Storm Water Management and Erosion control
Location Name: TEP ROCKY MOUNTAIN LLC SAVAGE PA 21-9 Pad
Location ID: 324452

**Location Overview: Location is within High
Priority/Density/Black Bear Habitat areas. Location is within
Rule 411a Surface Water External Buffer. Location is within
close proximity to Rule 411.b Generalized External Buffer.**

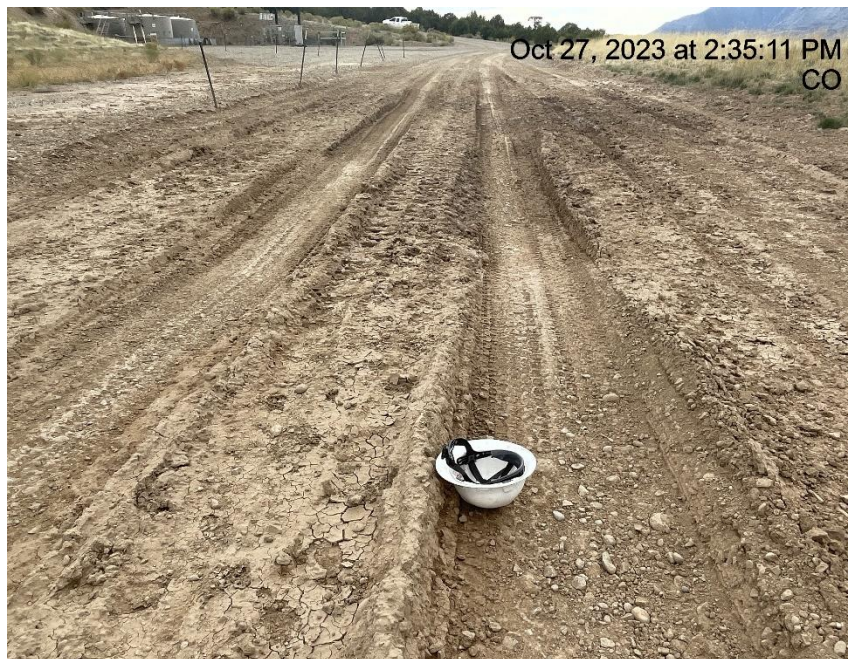
Photo # 4708 Lack of stabilization/compaction/insufficient BMP's
